PINE VIEW ESTATES

GRADING & EROSION
CONTROL PLAN

PCD FILE NOS: SP-20-019

GRADING & EROSION
CONTROL PLAN

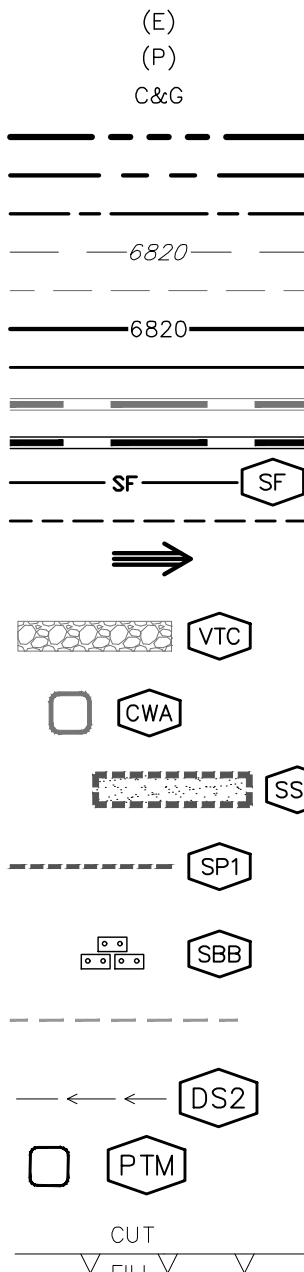
Review 1 Comment:

Per direction from the State, subdivision developments that include impervious roads do not qualify for Exclusion E (Large Lot Single-Family Site) Exclusion on the PBMP form. Therefore, some sort of permanent WQ facility should be included in design.

Review 2 Follow-up Comment:

See comments on PBMP Form. If Runoff Reduction is selected as SW quality control measure, show location and/or note on this GEC Plan.
